**NATIONAL INSPECTORATE FOR ENVIRONMENT,
NATURE AND WATER**

Case number: 14/00020/5/2009

Subject: Consultations in transboundary context for “Amendment of the Zone Urbanism Plan for Rosia Montana Industrial Area”

Figure quoted from the Romanian answer (modelling by Capra)

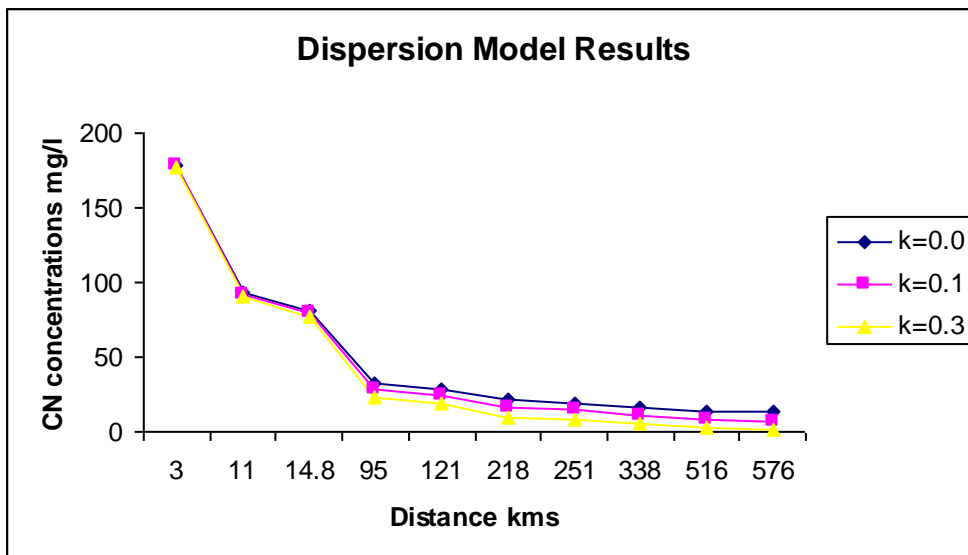
The answer given on page 43 as a criticism to the Hungarian modelling results is just a nicely provided support to, or rather repetition of, the Hungarian modelling study (no wonder as all data and all models were the same).

The Figure below shows the cyanide concentrations along the river given a 29.4 tonne release of cyanide from the Dam. This is equivalent to scenario 2b in the EIA with 5,880,800 cubic metres of water with a concentration of 5 mg/l. The velocity and dispersion coefficient are 1 m/sec and 82 m²/sec, respectively, for the simulations and in the Figure below three results are shown for decay rates of 0.0, 0.1 and 0.3 days⁻¹. The simulations show high initial concentrations, much higher than the Dam and this proves that it is simply an artefact of the dispersion model due to the assumption of instantaneous discharge. As it is stated above, due to the basic laws of chemistry it is impossible for the concentrations to increase from 4 mg/l to 27 mg/l.

This figure copied from the Romanian material (not allowing a correct reading of the data of the plot) yields at $K=0.0$ roughly the same result at Nagylak/Nadclac of 9 mg/l Cyanid as the Hungarian result (Jolánkai's simulation) presented earlier in Bucurest (see the Figure below).

Figure quoted from Hungarian presentation (simulation by model DYNDIS of Jolánkai and Biró)

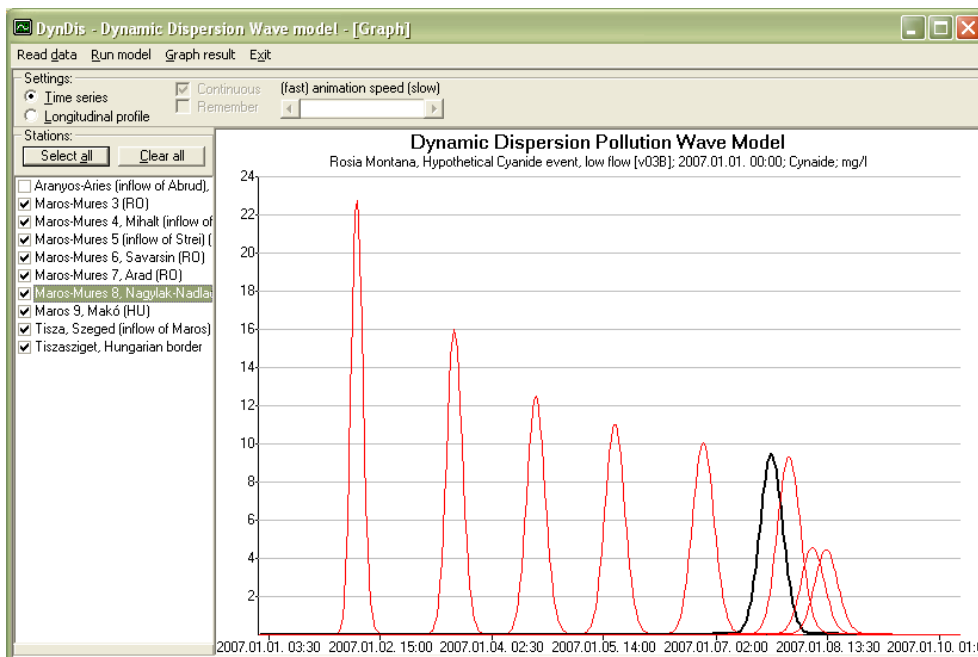
Thus the **two results are practically identical**, an obvious result as the same assumptions and same basic model theories are used. Correctly interpreting the simulation results of Prof Capra the answer is as follows:

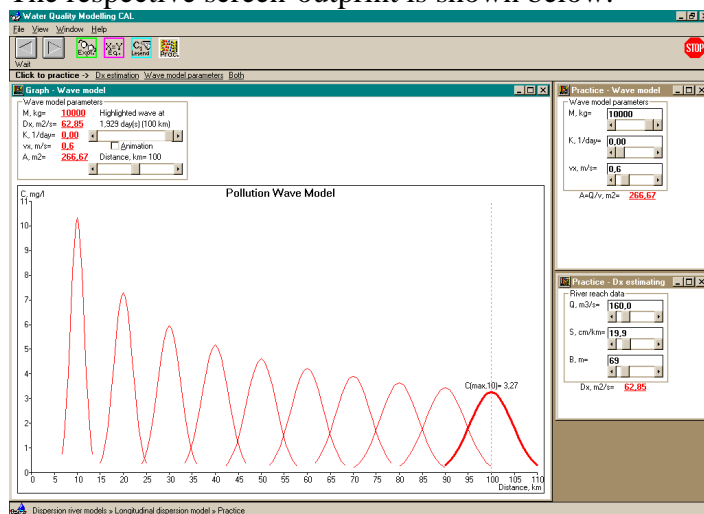
Another quite reassuring fact (but not a proof as was stated by the Romanian Party) of the Hungarian assumption of instantaneous mass release is that **perfect simulation of the actual Nagybánya/Baia Mare cyanide spill** (very accurately monitored within Hungary with several points for each stations, see www.tiszariver.com) was made. This assumption may be easily checked by using the Computer Aided Learning facility WQMCAL, Basic River and Lake Water Quality Models, developed by Jolánkai G and Biró I for UNESCO (downloadable at:

only one should enter 10 times less total mass (10 tonnes instead of 100 tonnes), as this teaching aid allows only 10 tonnes input as maximum (as at the time of making this computer aided learning material the cyanide catastrophe had not yet happened).

The figure shows the simulation of the BaiaMare/Nagybánya spill until station Csenger, Hungary (at 100 km distance from the source), using the WQMCAL teaching aid (result should be multiplied by 10), the measured maximum cyanide concentration at Csenger was 32,4 mg/l
